MEMORANDUM

FILE NO.: CSP2013 0007 & CSP2013 0010

PROPOSAL: Vacate three parking spaces in CBJ ROW along Front Street and four parking spaces in CBJ ROW along Seward Street.

Applicant: MRV Architects/ Sealaska Heritage Institute

Design documents for the Walter Soboleff Center, and associated street and sidewalk changes, assume the removal of on-street parking stalls, with four located along Seward Street, and three located along Front Street. An attached graphic illustrates the stalls in question.

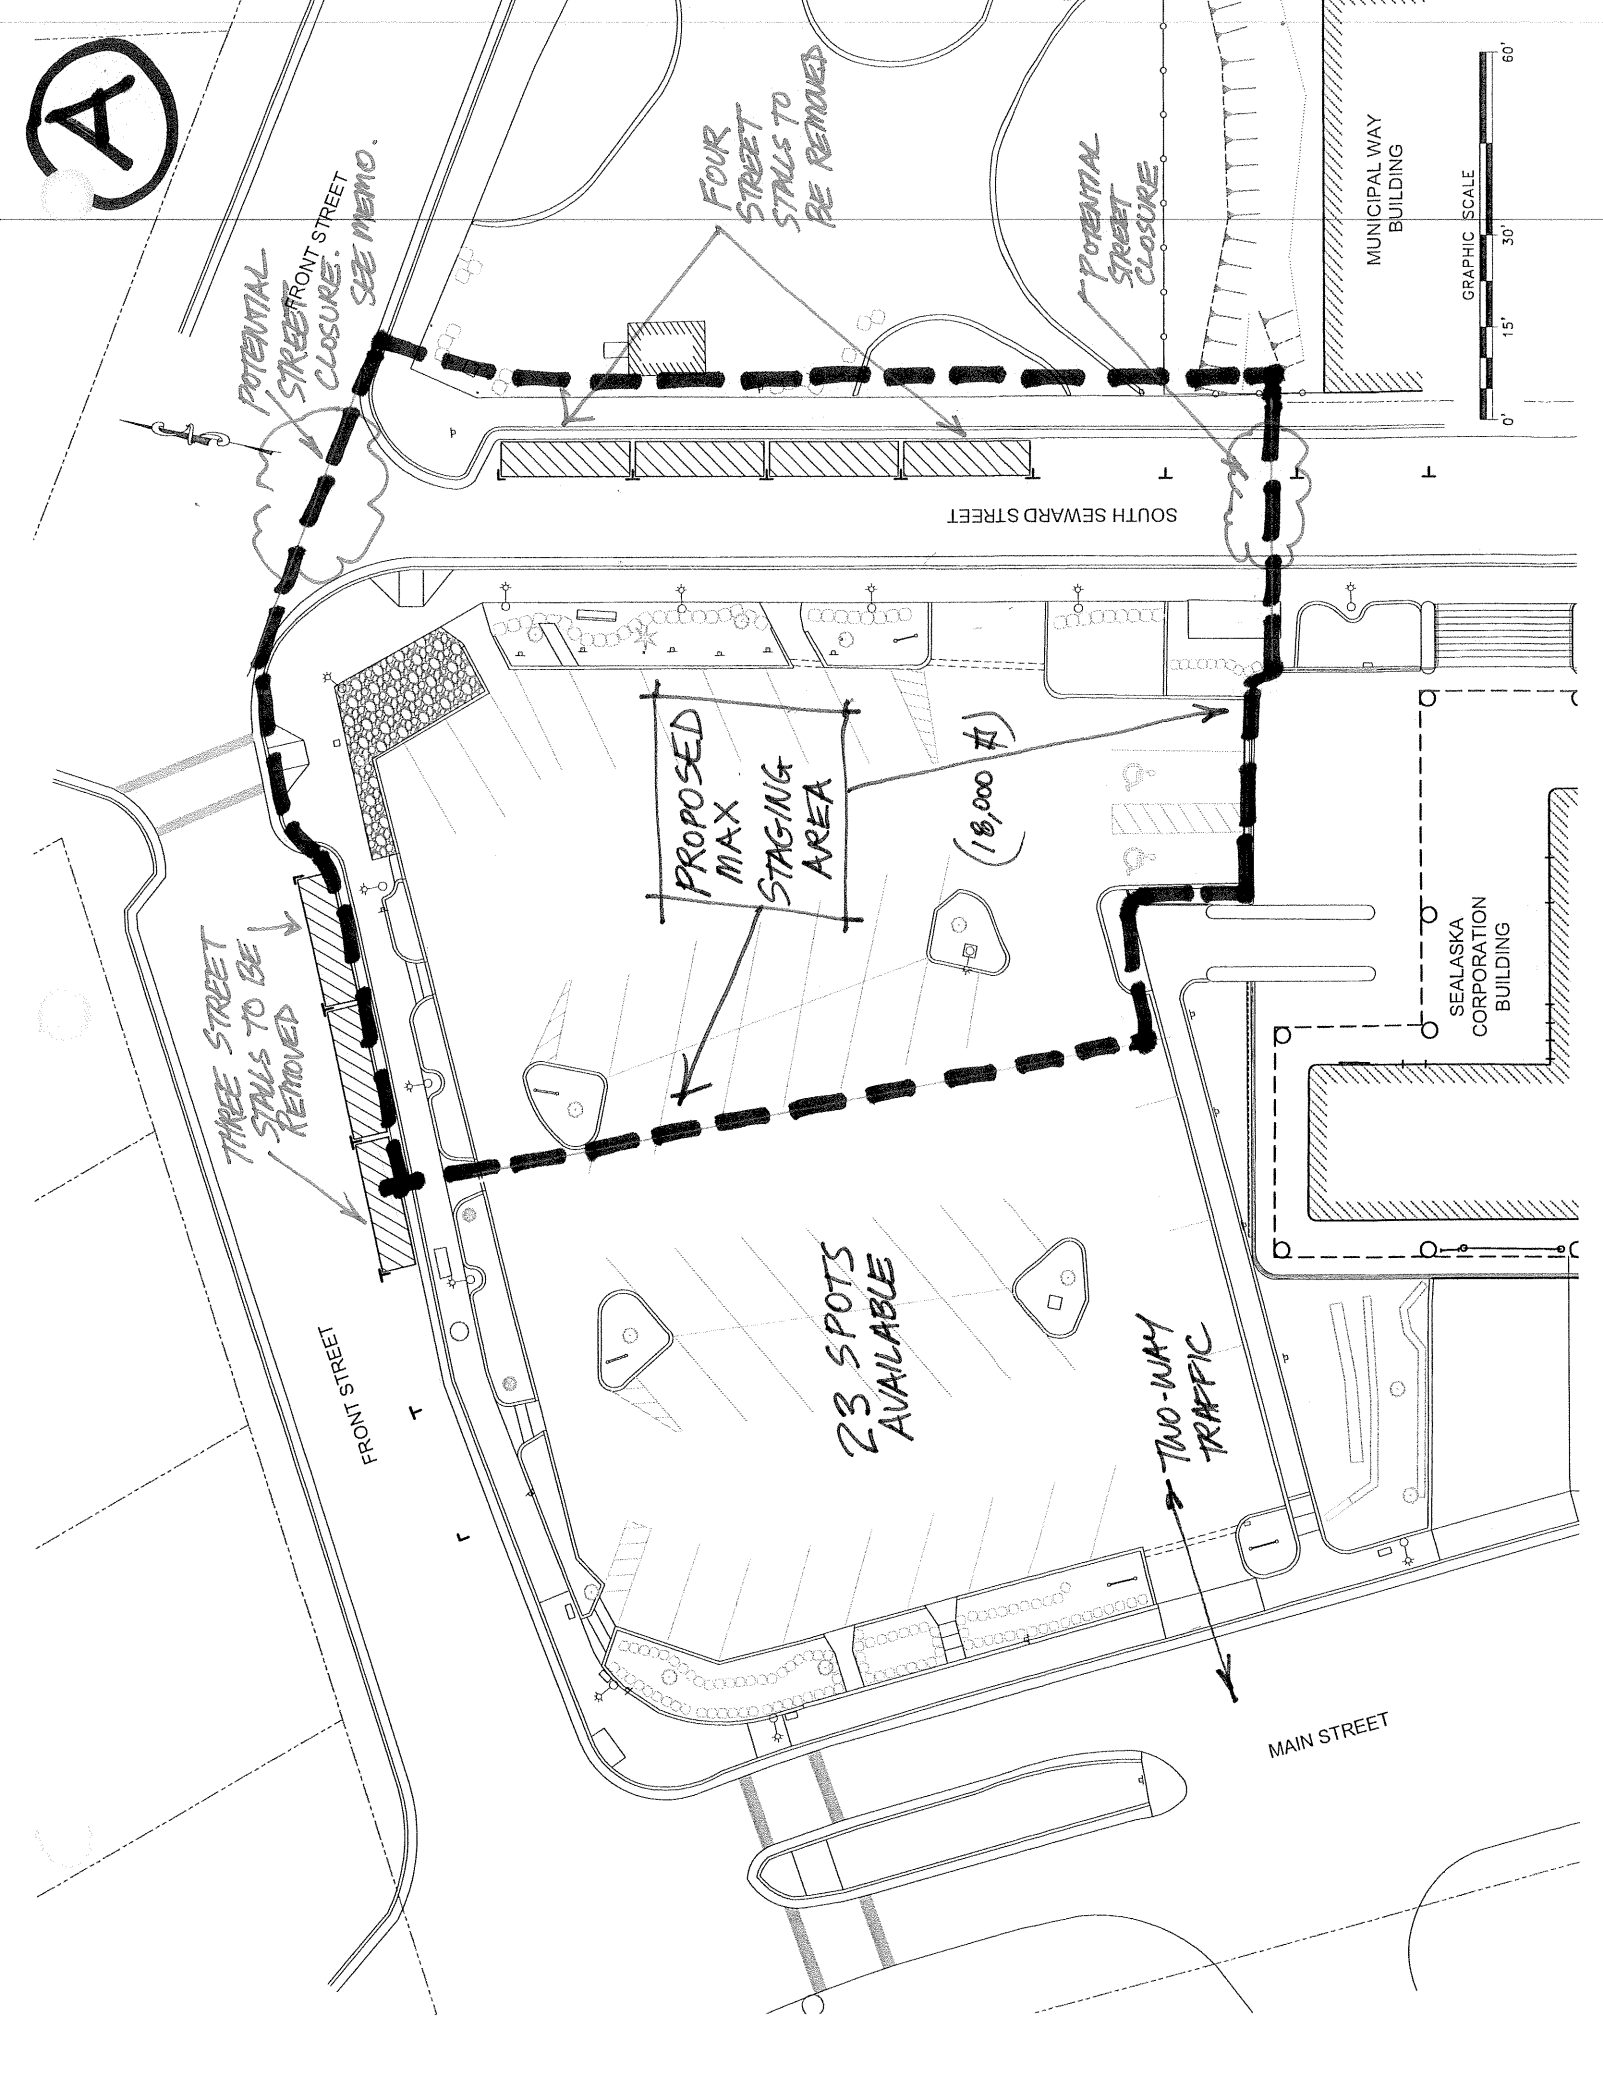
General Engineering objects to the closure of Seward Street. The blocking of Seward Street presents an issue of health and safety. Seward Street is critical to turning movements and fire department apparatus access. Also blocking the street eliminates the high use **LOADING ZONE** next to Copy Works as the access will be cut off. The sketch misrepresents the impact on parking.

Parking downtown is a premium and should not be removed. General Engineering objects to the removal of four parking stalls on Seward and the three stalls on Front St.

Parking vacation: Your drawing does not show an AELP utility lid/vault near the 3 stalls on front street for vacation. As long as the new design does not impact this lid/vault, I do not see any problems with vacating any of the 7 parking stalls from a utility perspective.
